Comments on NIST NCSTAR 1 Draft

July 27, 2005

James Quintiere, Prof
Fire Protection Engineering
University of Maryland
College Park, MD 20742
jimq@umd.edu

Figure 1. UL and Isolatek results.

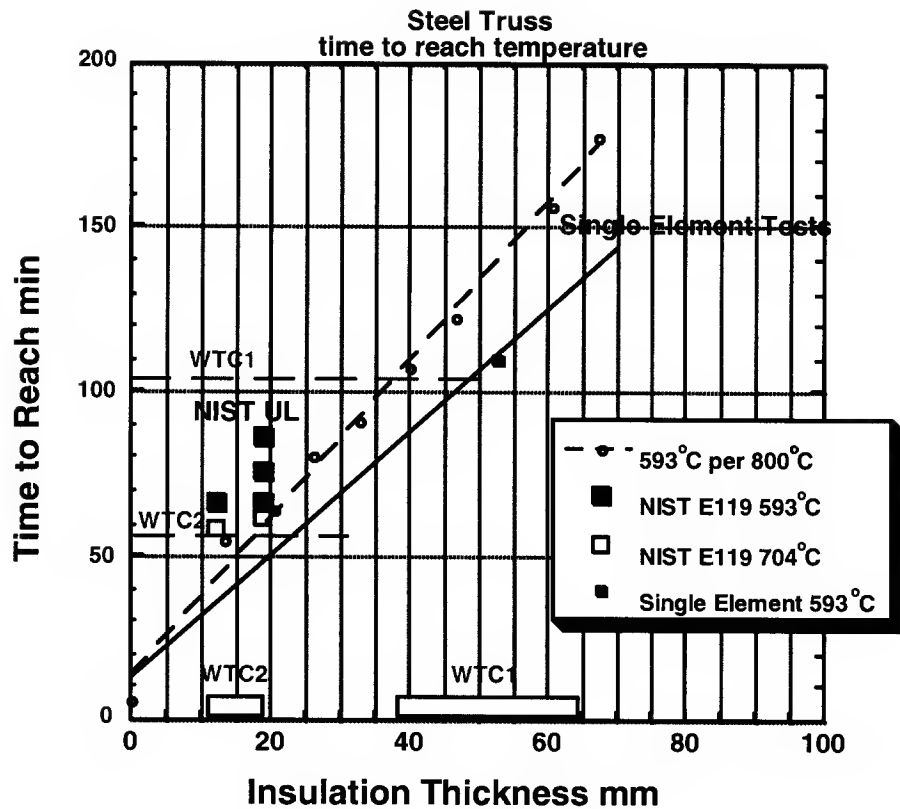
It is noted that the predicted times to reach the critical failure temperature of the truss steel of 55-73 minutes for WTC 2 and 111 minutes for WTC 1 in Table 1 is consistent with the building collapse times of 56 and 102 minutes, respectively. These predicted heating times are also consistent with the NIST measured heating times (to 66 to 86 minutes, although the reduced scale 17 ft span tests compromised heat transfer) in the UL furnace tests at fire temperatures comparable to 800 °C shown in Table 2 taken from NIST. Indeed, the UL time to reach 1100 °F (593 °C) for the 35 ft span ranges from 66 to 16 minutes which is consistent with 73 minutes in Table 1 and an extrapolated time of 50 minutes for the UL temperature conditions. (See Figure 1.)

Consequently, if the truss elements with specified insulation levels of ½- ¾ in. for WTC 2 and 1 ½ in. for WTC 1 can be heated to about 600 °C in an 800 °C fire at computed times of 55-73 minutes and 111 minutes, respectively, and NIST and others determined that the truss would cause either column buckling or connection failure at 600 °C or below, then this mode of collapse cannot be discounted. This is especially compelling since the collapse times are consistent at 56 and 102 minutes. Moreover, it is commonly known that floor sections were collapsing up to 20 minutes before the full collapse of each of the buildings. NIST has not addressed those early failures.

Figure 2. Predicted upper layer temperatures at various locations on the 97th Floor.

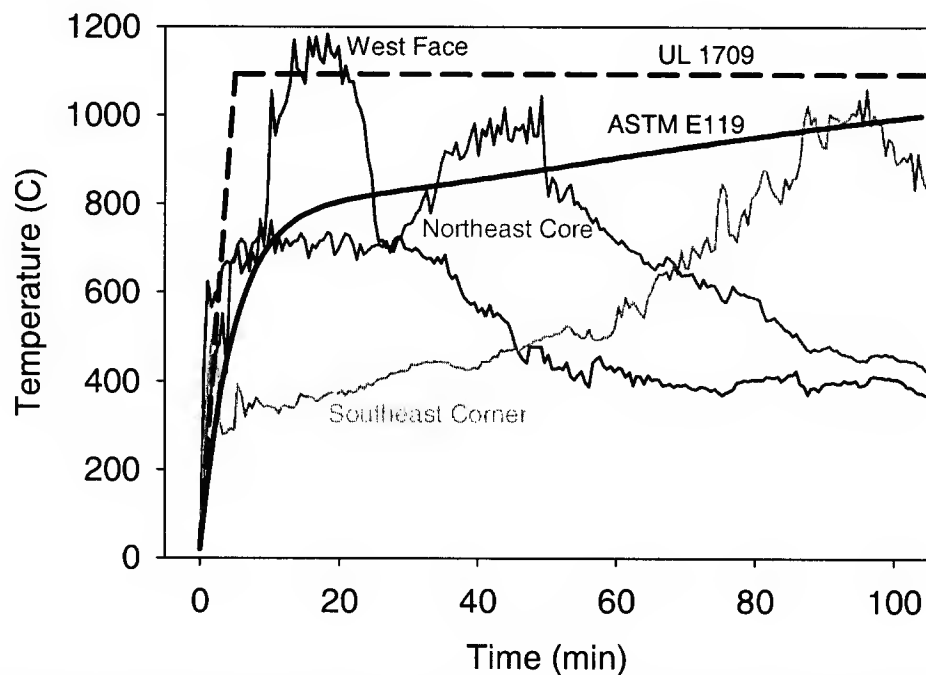
The results of the NIST fire predictions are based on a fuel loading of 4-5 psf. These levels are based on data from the impacted floors of Marsh & McLennan in WTC 1. NIST says this has “high” accuracy [p 119]. They find for WTC 1 that a given floor did not have uniform temperatures. “At any given location, the duration of temperatures near 1,000 °C was about 15 min to 20 min.” [p 127] Upper layer temperatures are shown in Figure 2 for WTC 1 97th floor [NIST]. Temperatures generally exceeded 600°C for about 30 minutes, and for about 60 minutes in the core. In contrast, a scale model test conducted at the University of Maryland, representative of the 96th floor with a simulated fuel load of 11.5 psf, shown in Figure 3 indicates temperatures are generally over 600°C for 100 minutes, but are much cooler in the core. These results are distinctly different from the NIST simulation. One may be dubious of scale modeling, but it is a tried and true technique.

Figure 3. Temperatures in a scale model of WTC 1 96th floor

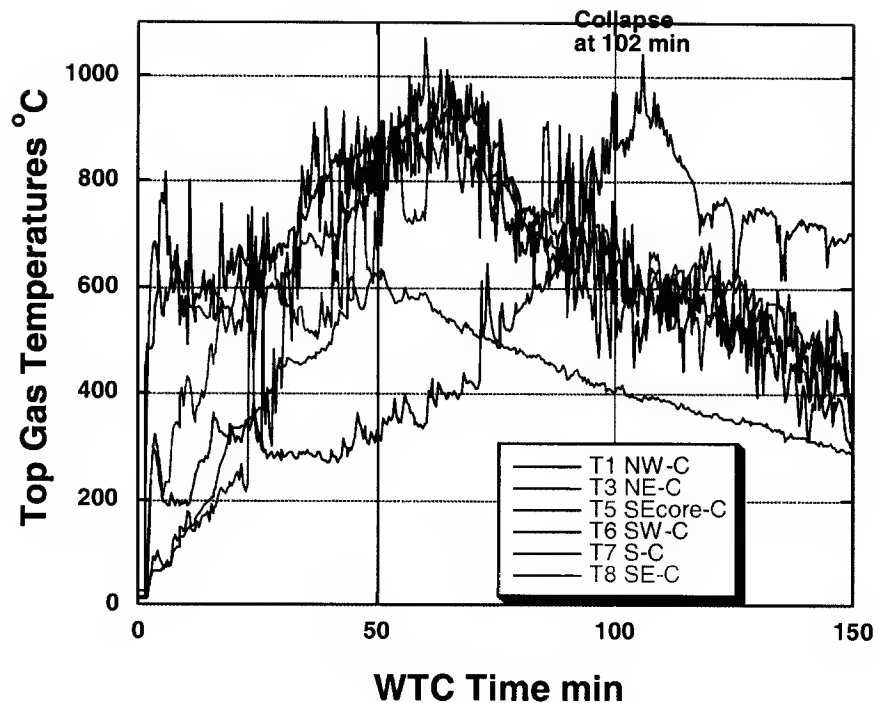
The heavier fuel load in the scale model was based on traditional office loadings and on anecdotal interviews of people familiar with the floors. Subsequently, we conducted a fuel load survey of the 96th floor based on architectural plans obtained from the furniture installer. This led to a conclusion that a loading of 10 psf or greater was the case. Appendix C contains the details in a report. Figure 4 shows a section of the architectural plans used for the 96th floor. A handwritten notation indicates a section of common files that ringed the core of the office space. There were 170 of these 4-drawer lateral files. NIST completely ignored this fuel load (and others) in their assessment. We assigned 100 lbs of paper per draw (a sub-capacity level) giving 68,000 lbs for this contribution. In addition, there were other common files and a storage room that gave a grand total of 95,400 lbs not included by NIST. In the survey conducted by Kate Stewart, estimates of paper and personal items were included in the workstation loads based on typical office conditions. Our total floor combustible loading was estimated at 302,062 lbs

Figure 4. Section of furniture layout WTC 1 96th floor

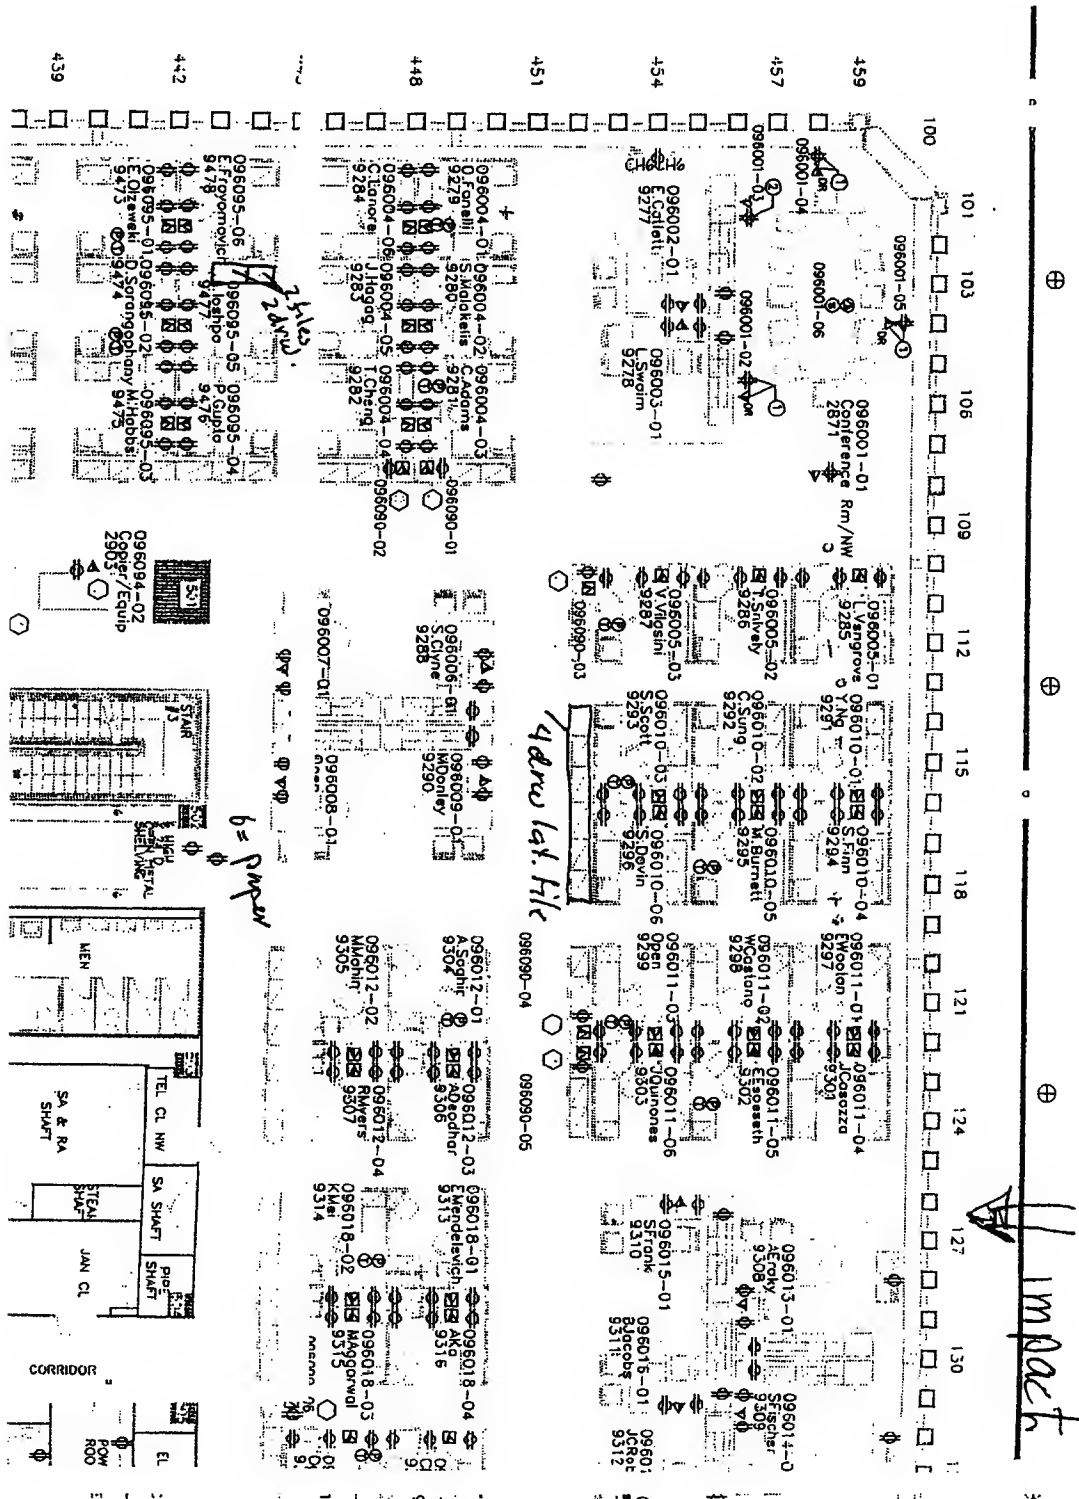
compared to 134,640 lbs determined by NIST. Taken over the office floor space area (31,013 ft²), this computes to 9.7 psf and 4.3 psf for NIST. Our paper extimat per file draw is well below

capacity, so the loading we determine is likely too low. Indeed, it was told to us that Marsh was a “paper hog” and “kept everything”. Paper fuel in closed files is de-rated in fire design considerations, but the aircraft impact could have opened the file draws.

Figure 1. UMCP estimate of how the total workstation weight is distributed.

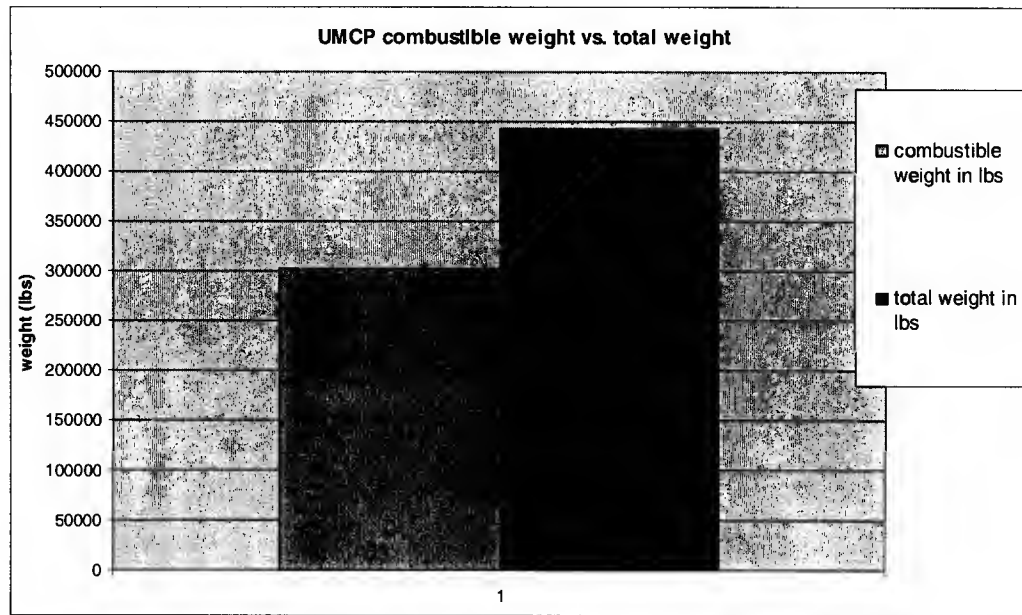
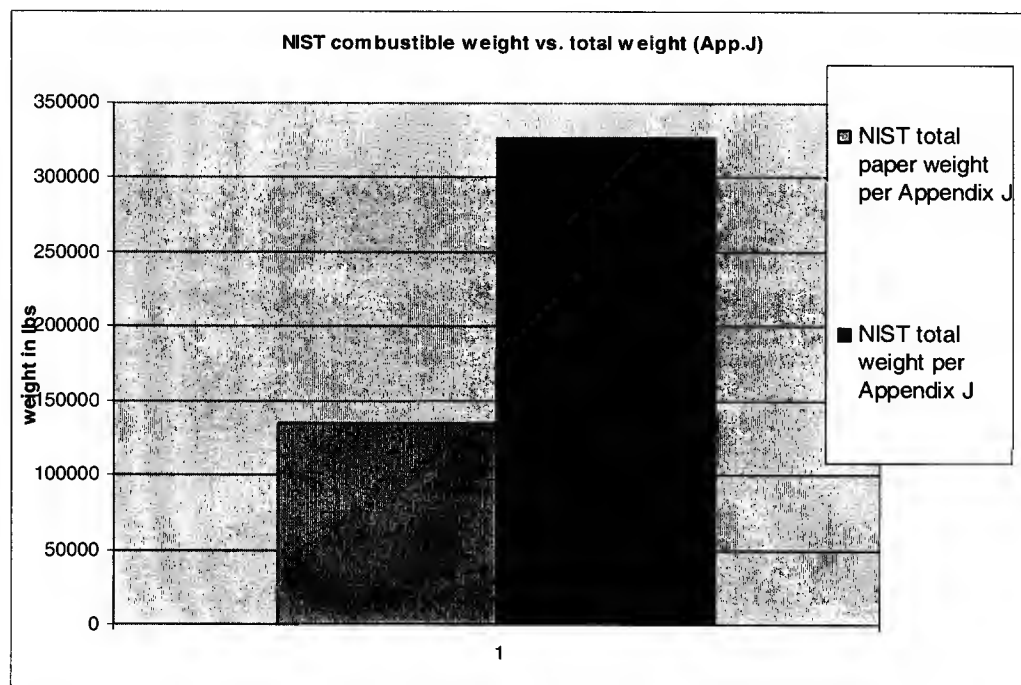
- The cabinets used by NIST contained two reams of packed paper, which is not consistent with the files that I weighed. The significance is that the tighter the packed paper is, the less air can get in to feed the fire whereas, typical files are not uniform in size or spacing and leave room for air to supply the fire.
- The following are graphical representations of the difference between the paper weight not included (NIST) and the total weight inclusion (UMCP):
